Arlington Conservation Commission

Date: Thursday, February 6, 2025

DEP #091-0356: Notice of Intent: Thorndike Place (Continued from 01/16/2025).

The Conservation Commission will hold a public hearing under the Wetlands Protection Act to consider a Notice of Intent for the construction of Thorndike Place, a multifamily development on Dorothy Road in Arlington. Areas proposed to be altered include Buffer Zone to Bordering Vegetated Wetland and Bordering Land Subject to Flooding associated with Alewife Brook.

© 2023 BSC Group, Inc.
SCALE: 1" = 30'
FILE: \Civil\Drawings\2340700-LM
DWG.:
JOB. NO: 23407.02 SHEET L-100

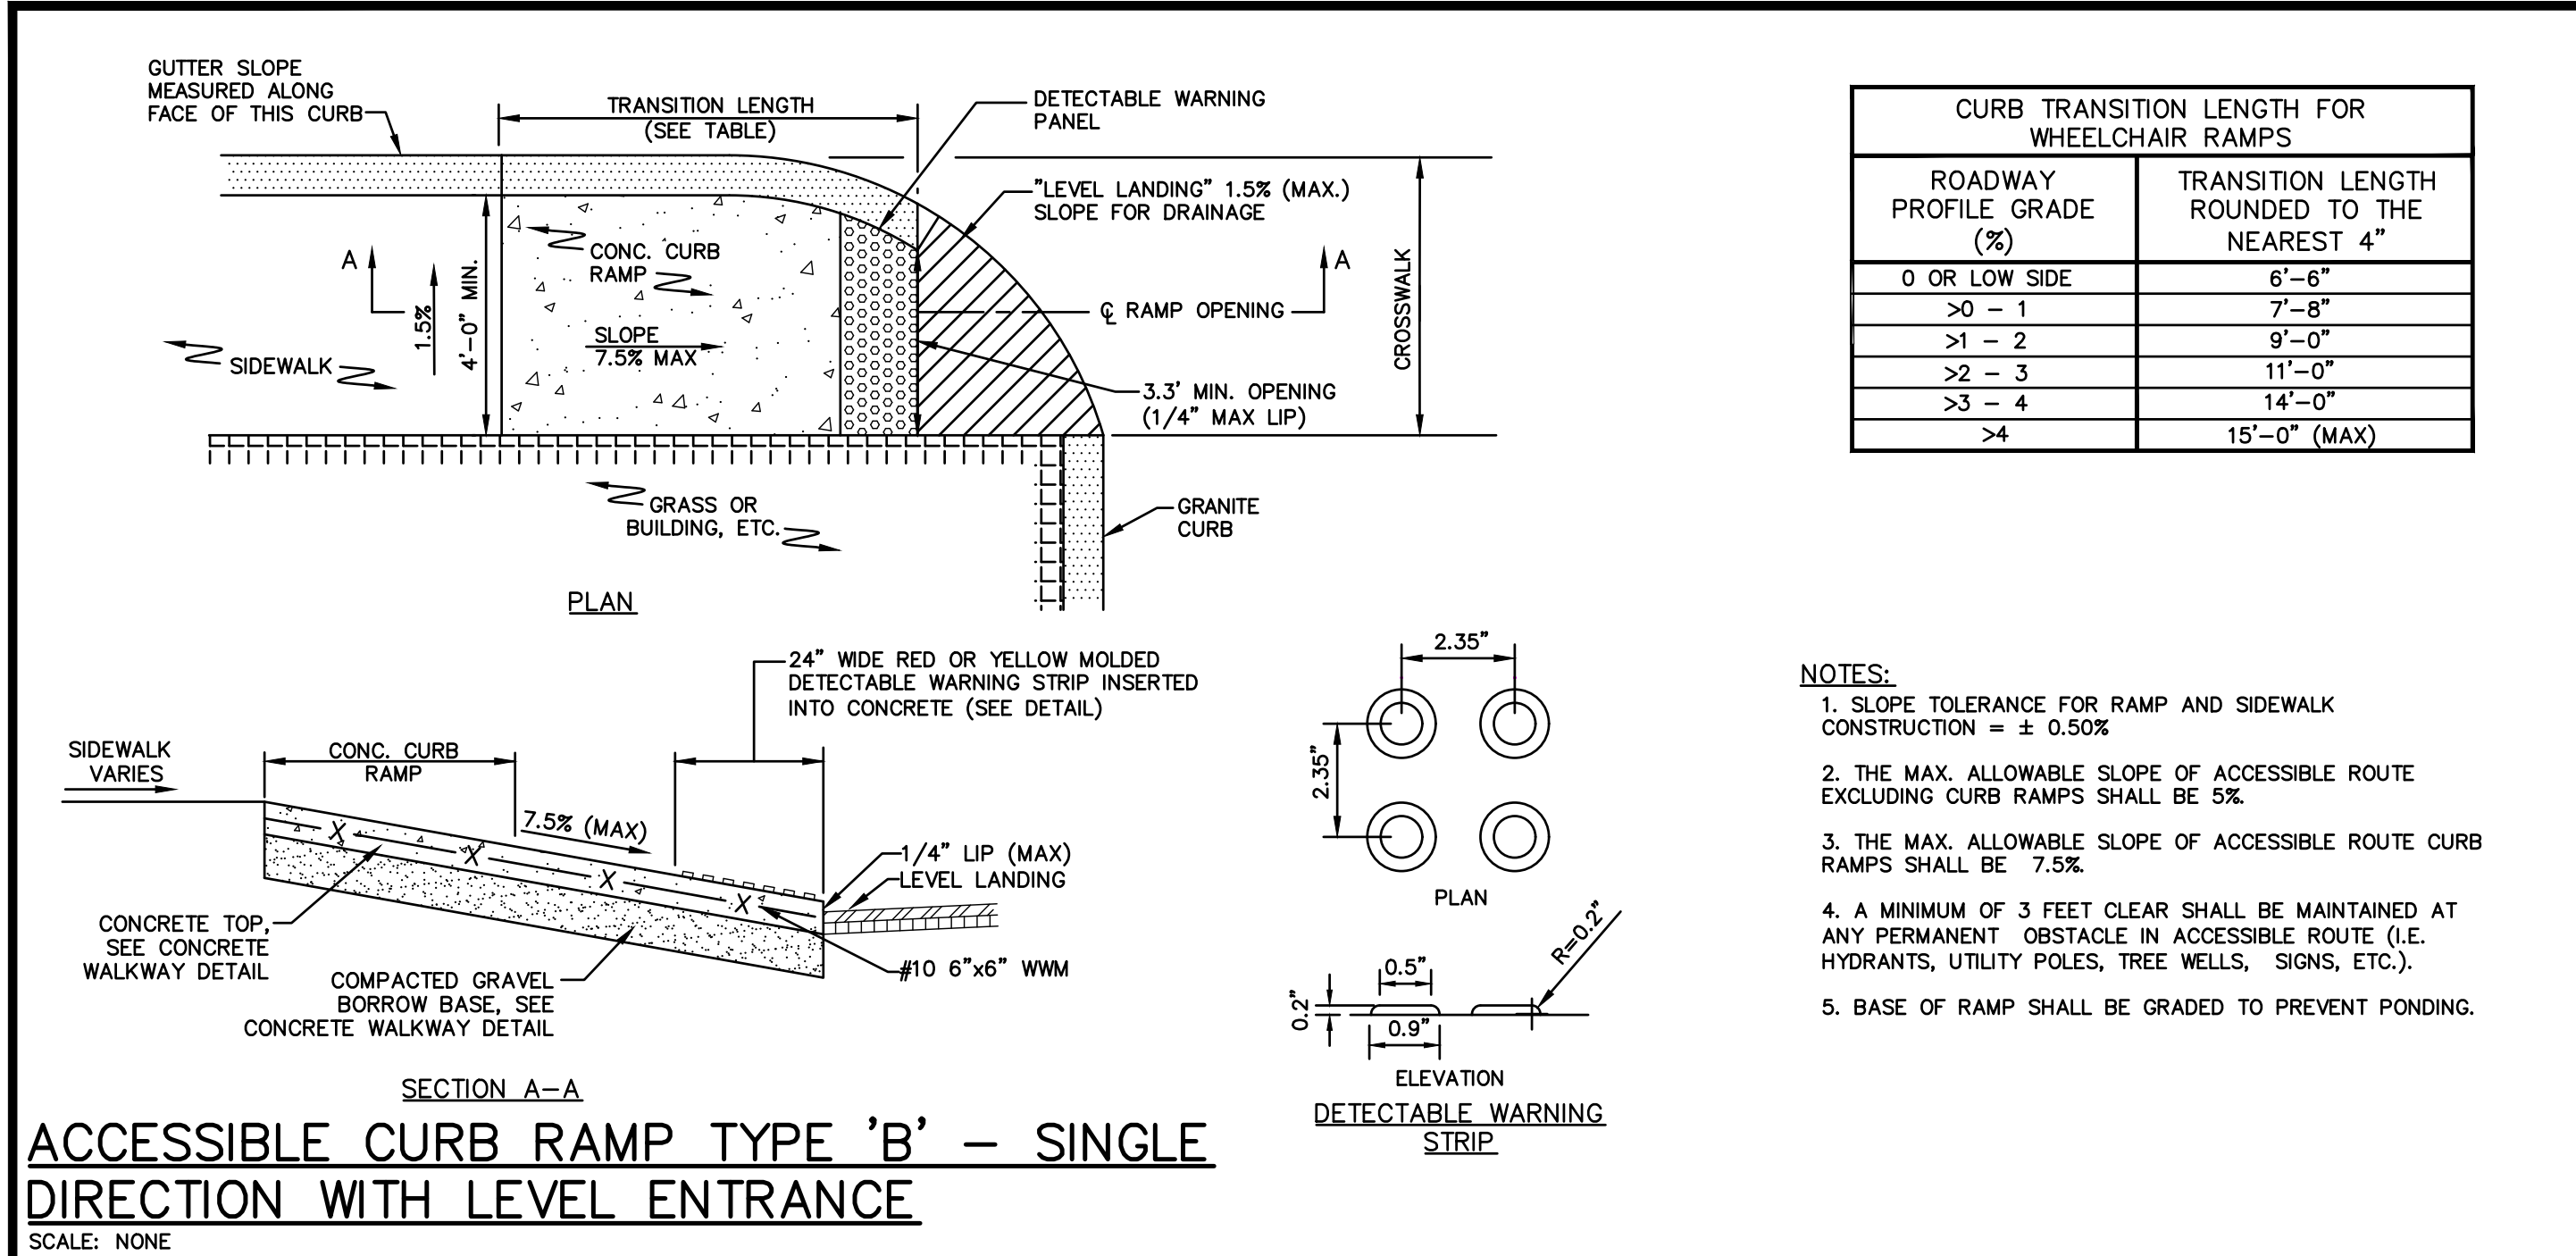
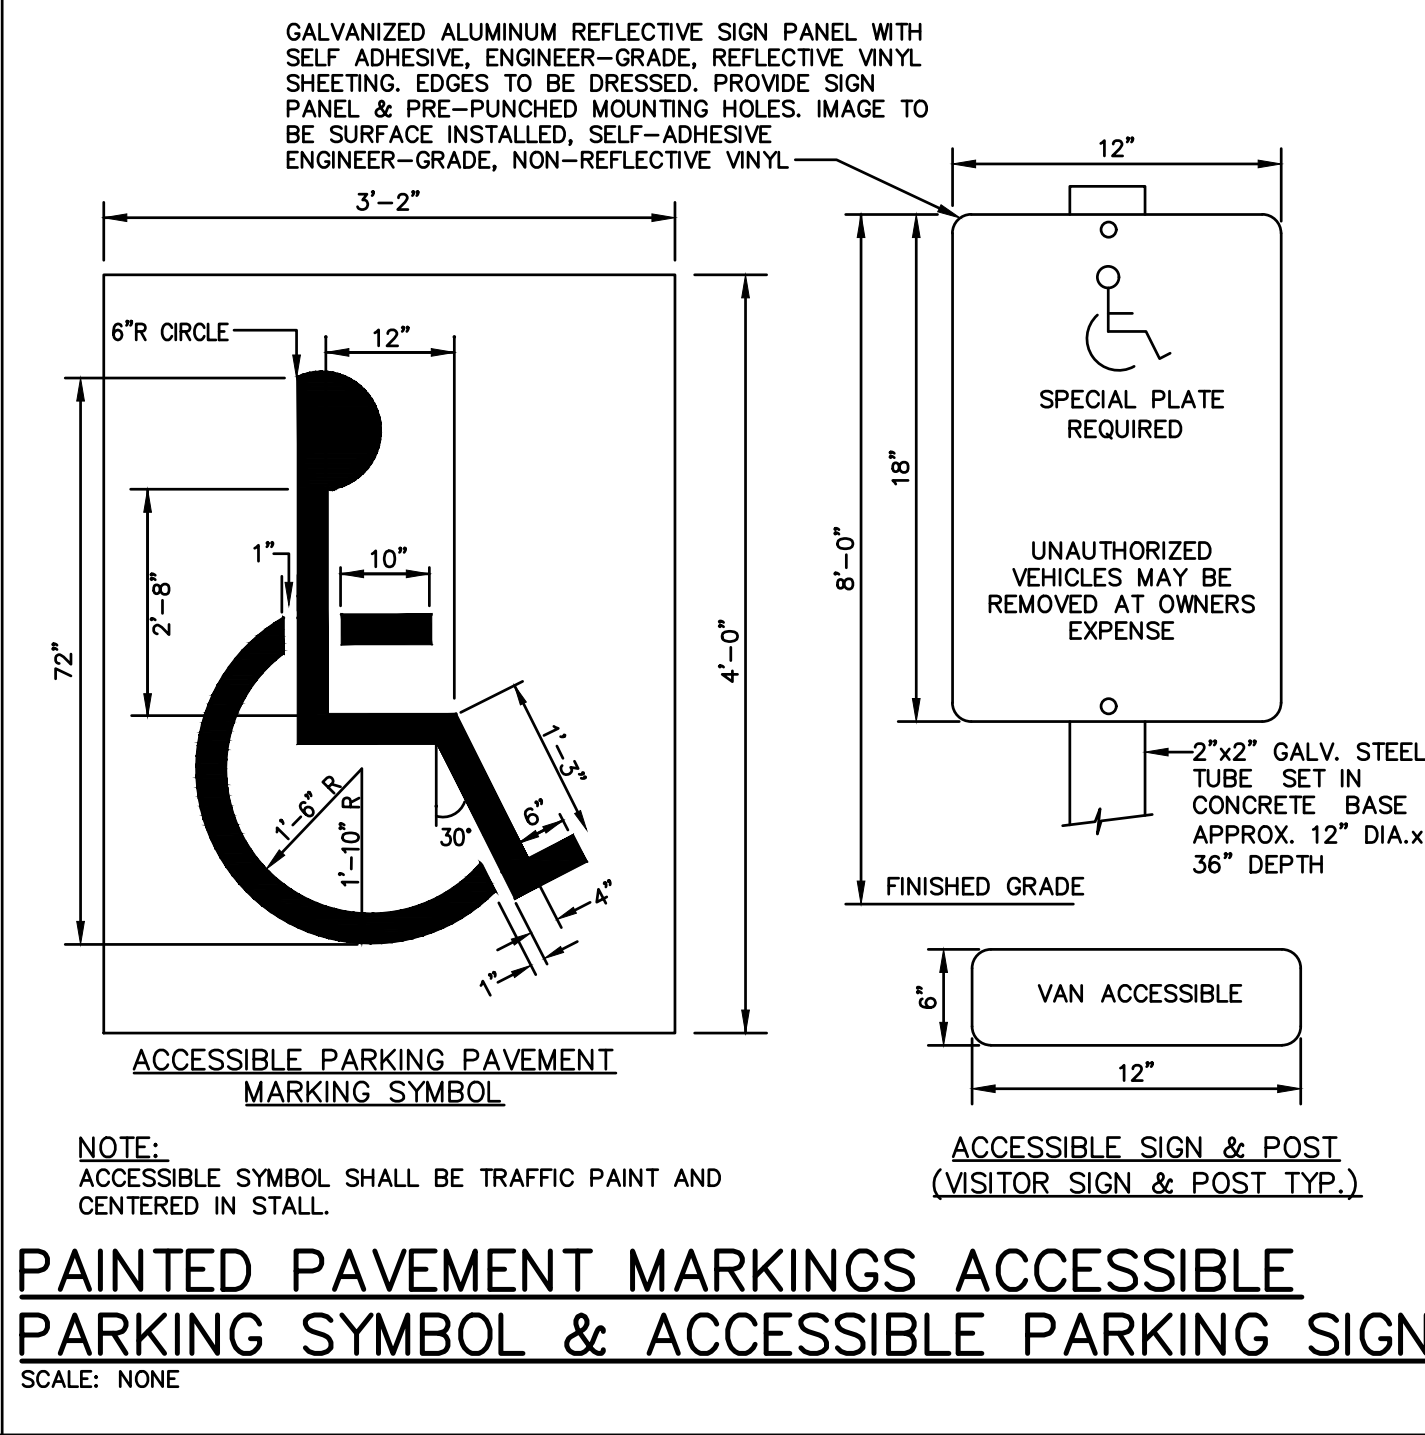
SWCA Comment 9: Sheet L-100, Plant Schedule. The plant schedule includes a number of proposed cultivars within the 100-foot Buffer Zone (e.g., *Clethra alnifolia* 'ruby spice', *Hydrangea quercifolia* 'ruby slippers', and *Hydrangea arborescens* 'annabelle'). In accordance with condition I.24 of the Comprehensive Permit, all mitigation plantings and plantings within all resource areas shall be native, non-cultivar species. Additionally, other cultivars are proposed in other areas of the site along side non cultivars of native species (e.g., pin oak [*Quercus palustris*] and green pillar pin oak [*Q. palustris* 'pringreen'])).

SWCA Comment 10: Sheet L-100. A note on the plans indicates that all dead trees (i.e., snags) that do not provide wildlife habitat per the landscape architect and wildlife ecologist should be removed. Snags provide a wide variety of valuable habitat functions for wildlife including forage for insects, perches to hunt from, shelter if there are cavities or cracks, and other functions.

BSC Response 5-1: Please refer to Sheet L-100. No tree is proposed within the restoration area or compensatory flood storage area that is not specifically listed in SWCA Comment 5. BSC is providing a color-markup of the restoration planting sheet to clarify proposed species placements.

BSC Response 10: BSC concurs with SWCA Comment 10 and has revised Sheet L-100 according to SWCA's Comments 1 and 10.

BSC Response 10-1: The note on Sheets L-100 has been updated to state, "2. Remove all invasive species according to ISMP; cut and remove (do not stump) all dead trees that pose a safety hazard to people or property as determined by Landscape Architect (LA) & Wildlife Ecologist (WE) with administrative approval of Conservation Commission; restore areas with native tree, shrub, and grass plantings as directed by LA. Utilize cut plant materials to construct snags and wildlife habitats as directed by LA & WE.
